**RESPONSE TO PHASE 2A CMP CONSULTATION FEEDBACK (DECEMBER 2020)**

**18 JANUARY 2021**

## CAMDEN GOODS YARD

## Appendix 3: Travel Time from Juniper Crescent to Primrose Hill Primary School

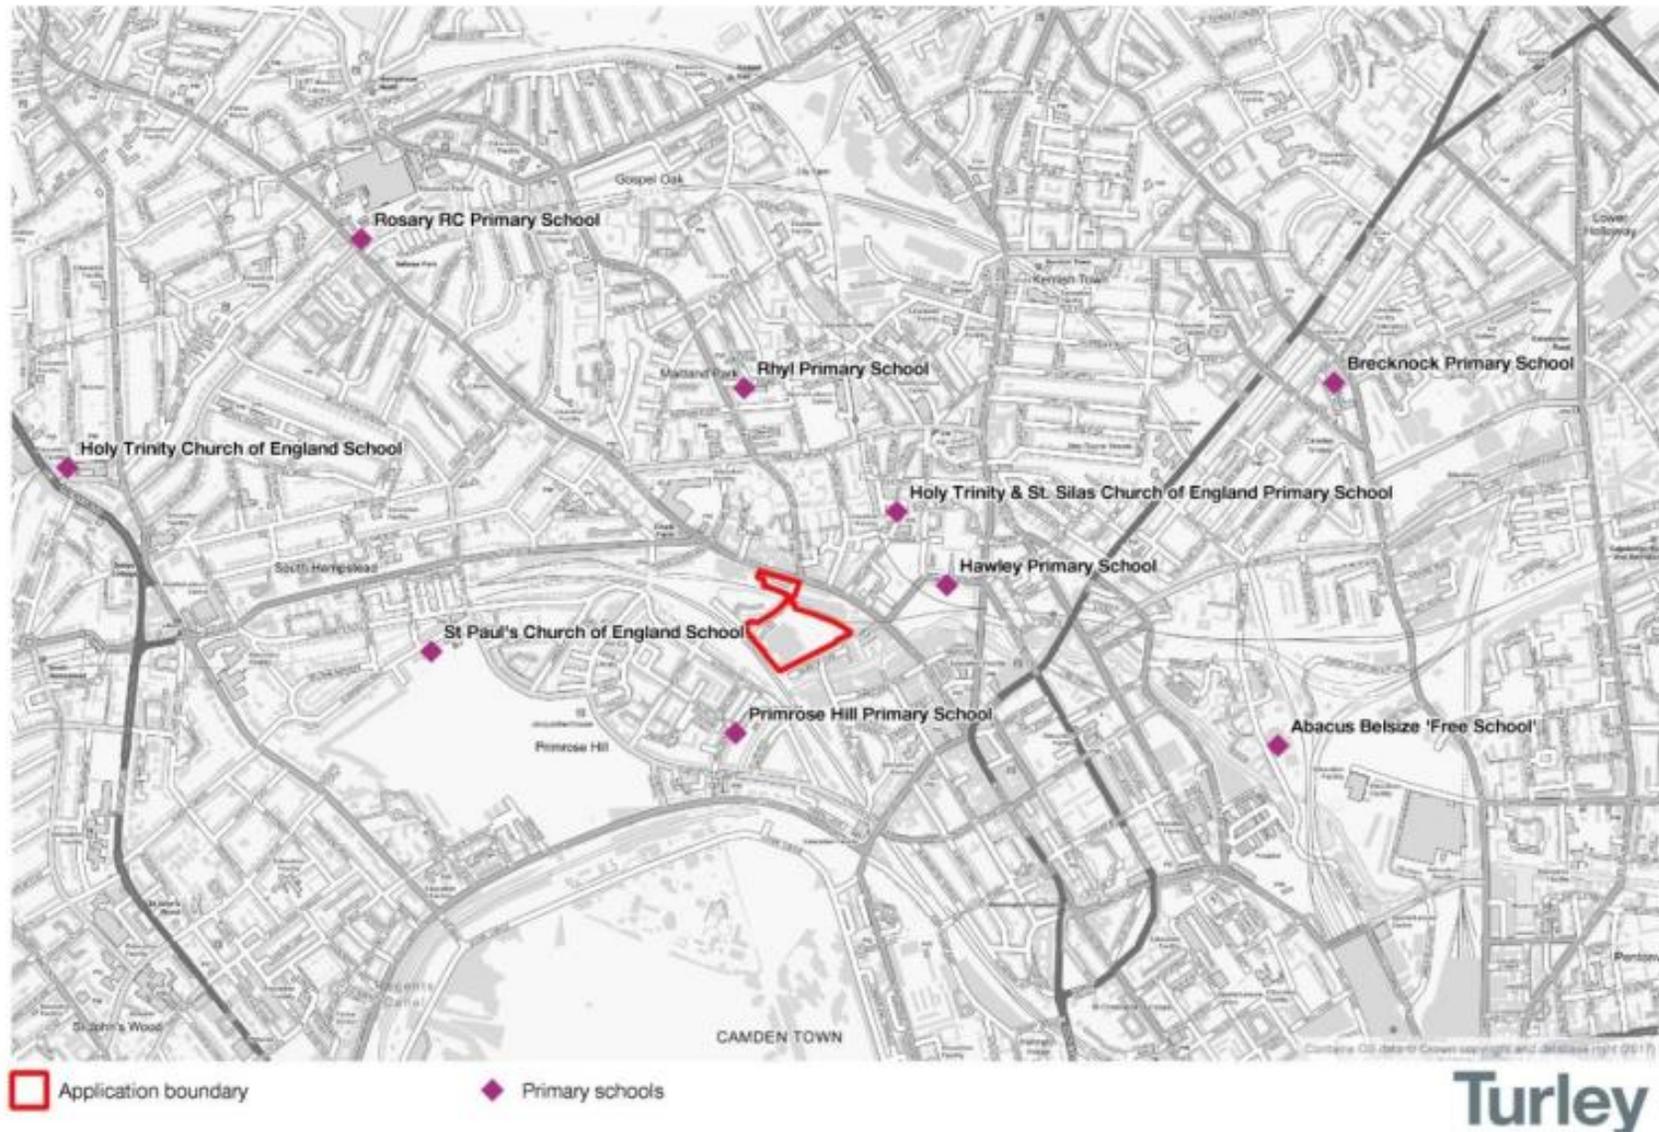
<p>28.</p>	<p>No access from Juniper Crescent to Gilbeys Yard is disgraceful because it means that children will have to walk a mile to get to school. Could St George set up a school bus run as this will be disruption caused by you?</p>	<p>Unfortunately St George are not able to provide access across the construction site during the majority of the construction programme for public safety reasons.</p> <p>We understand that journey times as a result of needing to take diversions will lead to slightly longer travel times. St George has provided information on the alternate diversion routes for residents in <b>Appendix 3</b> (Plans 3 and 4) of this document.</p> <p>We have reviewed schools provision in the area and believe this comment relates to Primrose Hill Primary School on Princess Road NW1. We have analysed the pedestrian (i) trip times via the existing Morrisons store via</p>

<p>Gilbeys Yard and (ii) via Chalk Farm Road and Camden Market to the school.</p> <p>Plan 1 in <b>Appendix 3</b> identifies the location of Primrose Hill Primary School in relation to the CGY site (red outline). Plan 2 (<b>Appendix 3</b>) highlights the existing route we understand is taken through the CGY site indicating an approximate walking distance of 0.4 miles and time of 8 minutes.</p> <p>We have noted in Plan 3 (<b>Appendix 3</b>) that the additional journey time with the diversion via Chalk Farm Road and canal would be 0.7 miles and 13 minutes. An increase of 0.3 miles walking distance and an additional 5 minutes.</p> <p>A second alternate route via Chalk Farm Road and Regents Park Road, illustrated in Plan 4 (<b>Appendix 3</b>) also offers a similar distance of 0.7 miles taking 14 minutes (an increase on existing time of 6 minutes). We do not consider a special school bus school service to be required.</p>

## Appendix 5: Location of Environmental Monitors within Camden Goods Yard Site

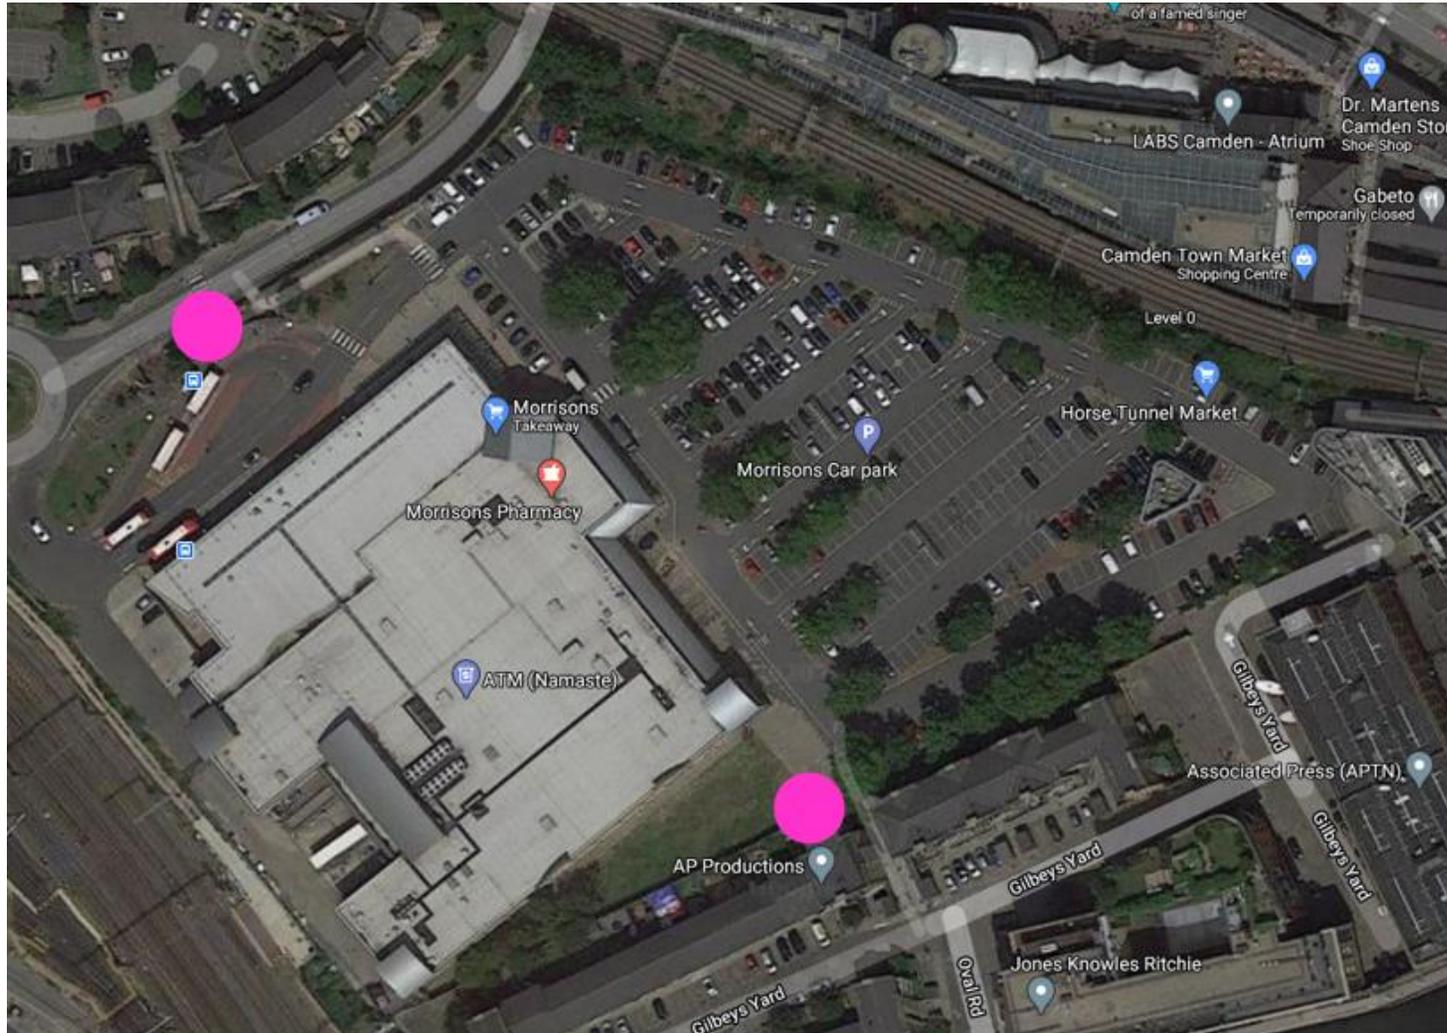
Query No.	Consultation Comment	Response
9.	<p>The noise monitoring plan appears to be a generic document that has been slightly modified for this site (the mitigations/controls are all copied and pasted and barely site-specific). It is not made clear how many noise monitors they will have on-site and where. They have omitted key plant such as piling rigs, which from my experience are the noisiest bits of plant - especially when they are emptying their augers. Are there no noise trigger levels? What noise/vibration level results in them stopping works and finding alternative neighbour friendly methods of doing the work?</p> <p>Noise levels and attenuation are set out, but the plan doesn't show exactly where the noise receptors are to be located. The plan does set out a range of mitigating action points that could be undertaken to help mitigate the noise, we feel the following mitigations should also be considered</p> <ul style="list-style-type: none"> <li>• 3m high acoustic fencing/hoarding along those boundaries nearest to residential dwellings,</li> <li>• all plant and machinery to have a six-month audit to ensure all are operating at quietest levels</li> <li>• ensure soundproofing covers fitted to plant and machinery where necessary.</li> </ul>	<p>Section 35 of the CMP Phase 2A CMP confirms details and the location of where two environmental noise, dust and vibration monitors will be located within the site. One monitor is located next to Juniper Crescent and the other next to Gilbeys Yard, the two most sensitive receptors to the CGY site. The location of the two environmental monitors is also provided in <b>Appendix 5</b> of this document.</p> <p>The environmental monitors will capture 3 months of data prior to the first works (demolition) commencing in March 2021 to establish a baseline against which works can be monitored. This monitoring commenced in early December 2020.</p> <p>The monitors will provide alerts to the construction team if prescribed levels are breached so a review and then action can be taken if needed.</p> <p>The process to agree levels will be via a Section 61 application (the process by which contractors apply for 'Prior Consent' for noise generating activities during the construction phase of a development) and based on guidance in British Standards for noise and vibration respectively. These accord with Camden's minimum requirements also. St George will agree the maximum acceptable noise, dust and vibration levels with the Council for each stage of the project once each key subcontractor has been appointed (for example demolition and substructure (piling and basement)) and prior to the associated relevant works commencing.</p>

<ul style="list-style-type: none"> <li>• Installation on other soundproofing measures to neighbouring properties to mitigate noise impacts. <i>See above.</i></li> <li>• Soundproofing of the back of the homes facing the demolition site to be undertaken by St George in conjunction with OHG. With more home working, this is essential to avoid undermining peoples work and home life. <i>See above.</i></li> <li>• Avoid using any form of noisy driven piling. <i>As noted previously, CFA piling to be utilised.</i></li> </ul>
<p>10.</p>	<p>St George's CMP submission has concluded that the site is a "Medium Risk" site (according to their interpretation of GLA guidelines), despite the close proximity to houses on Gilbey's Yard. This greatly reduces the monitoring/mitigation requirement on St George during construction (e.g. 2 dust monitors on such a large site instead of 4). Do <u>OHG</u> agree with this assessment?</p>	<p>The site is designated as a 'Medium Risk Site' in Section 38 of the Phase 2A CMP.</p> <p>The sensitivity of the area to dust soiling and human health impacts has been designated 'medium risk' in accordance with the London supplementary planning guidance (SPG) on the control of dust and emissions during construction and demolition.</p> <p>The location of the environmental monitors is identified in Section 35 of the CMP and <b>Appendix 5</b> of this document.</p>

## Appendix 9: CGY Welfare Village Indicative Location and Set Up

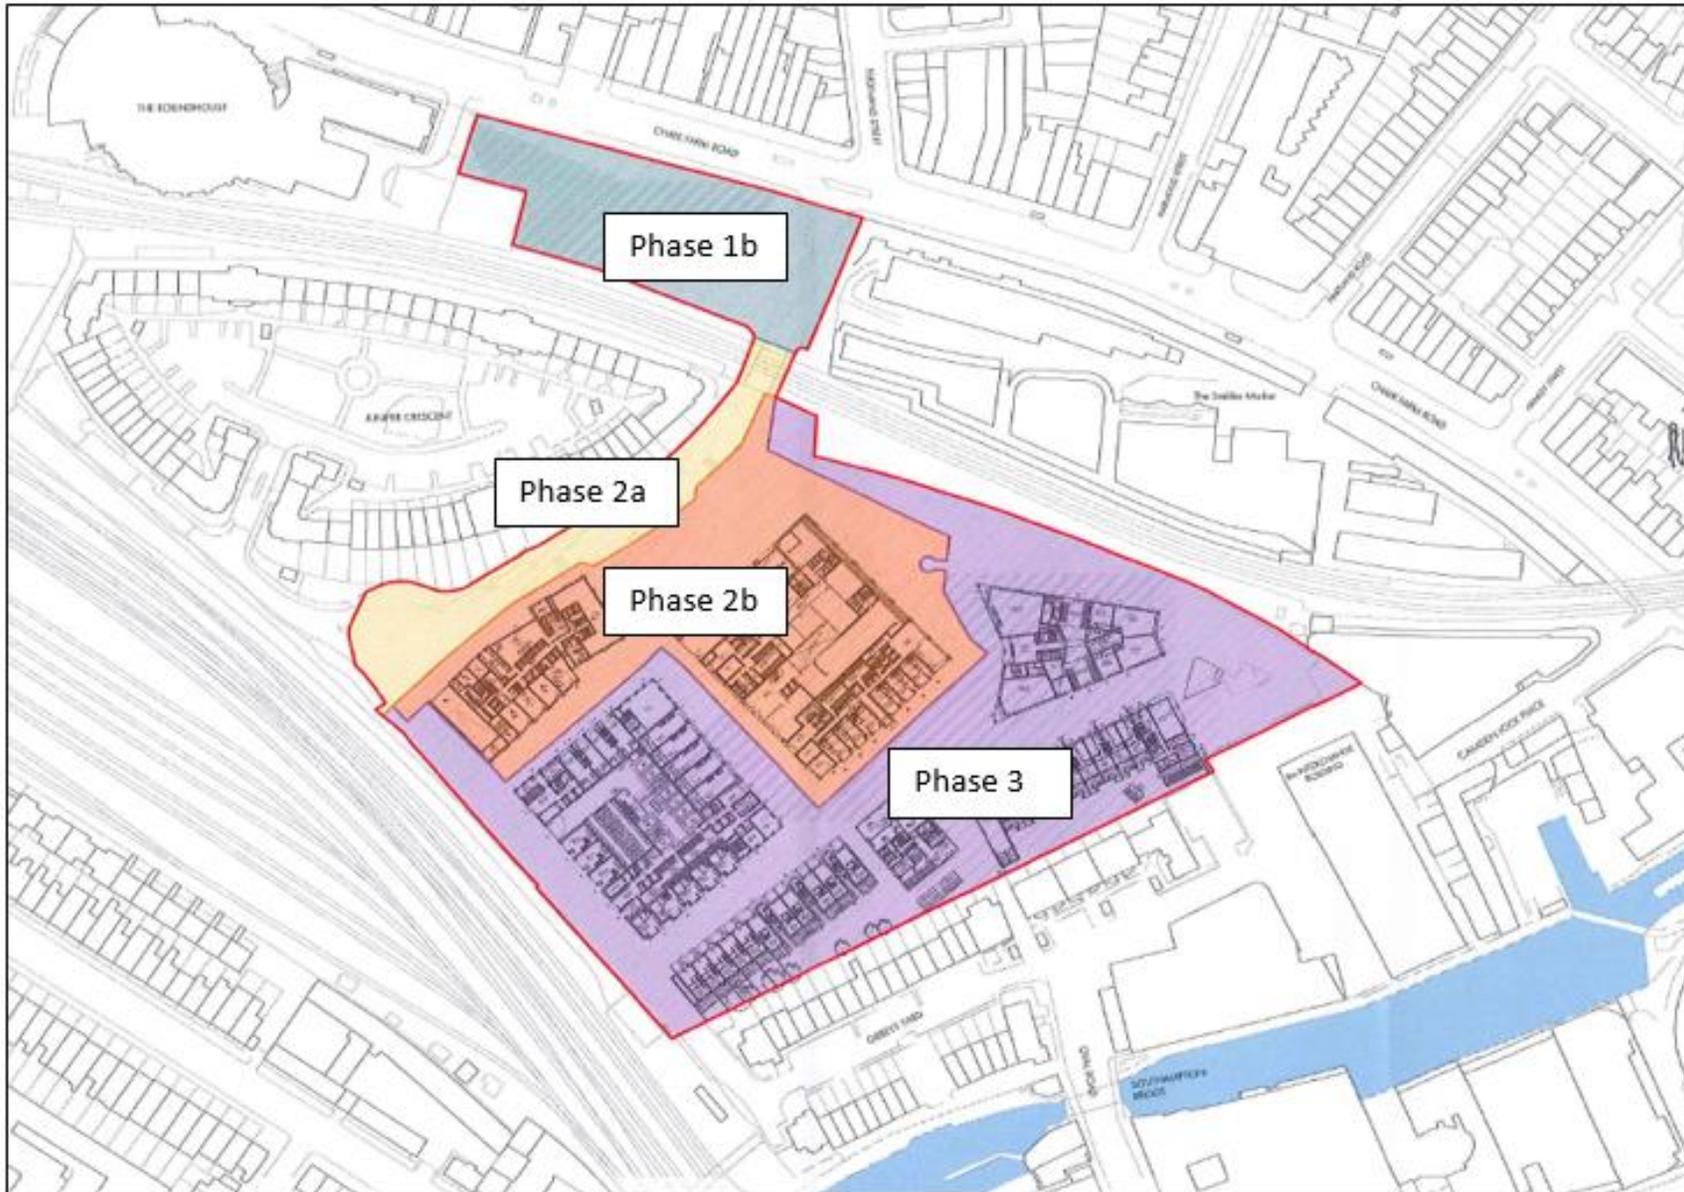
52.	How close will welfare village be to Gilbey's Yard?	<p>The proposed location of the welfare village is highlighted in <b>Appendix 9</b> of this document. The diagram provided is indicative. The reason it is indicative is that the early build packages (demolition and piling) will provide their own welfare within the site which will be small and more mobile to reflect the limited workforces required.</p> <p>The permanent welfare village will be installed circa August/September 2021.</p> <p>We will offset the welfare village away from the green space along the boundary as comments raised by OHG residents.</p> <p>We will also orientate the welfare village buildings so they do not look directly into Gilbeys Yard resident gardens, again reflecting on comments received from residents.</p>

55.	<b>Comment 1:</b> A big concern is in relation to the Welfare Village & Limited Parking sited at the southern end of the main site behind the east arm of Gilbeys Yard where I am resident.	<p>We have responded to comments on the welfare village in the response to <b>Query 52</b>.</p> <p>Given that 80% of the site is due to be excavated there are limited options on the location of the welfare village. We have explored the option of the</p>

<p>I have discussed the positioning of the Welfare Village directly with St George. I have put forward that it is sited elsewhere on the site, further away from the residential properties of Gilbeys Yard (for reasons I will discuss later on in this statement). For instance, one such site is the very south eastern area of the car park alongside the building once occupied by Gilgamesh and across from the Interchange building. This area is being relatively undeveloped in the overall scheme and is further away from the properties in Gilbeys Yard. St George have informed me that whilst this has been considered and is a possible option, it is more difficult for them when considering that an underground part of Camden Market lies beneath.</p> <p>Whilst I accept this, I feel the benefits to the residents of Gilbeys Yard more than justifies the increased difficulty it would pose the developer.</p> <p><u>Comment 2:</u> The developer has assured me that should the Welfare Village be sited as detailed in the current plan; it will be configured as best possible to reduce disturbance to the residents of Gilbeys Yard (both in general but especially outside of the permitted standard working hours of the site). These measures will include placing temporary structures etc. as far away from Gilbeys Yard as possible especially those that create noise (toilets etc). Furthermore, these will be orientated so that the noisier aspect of these structures face away from Gilbeys Yard. Obviously, these measures should be in place wherever the Welfare Village is ultimately positioned.</p> <p><u>Comment 3:</u> Welfare Village is too close to residents homes. Relocate in an alternative site such as the very south eastern area of the car park alongside the building once occupied by Gilgamesh and across from the Interchange building or an alternative site away from Gilbeys Yard</p>	<p>triangle land but our strategy for this area is to fence it off and not load it due to Camden Market which is situated below.</p> <p>As noted in other responses, full consideration will be given to the orientation and specification of the welfare village ensuring all mitigation considerations are implemented.</p>
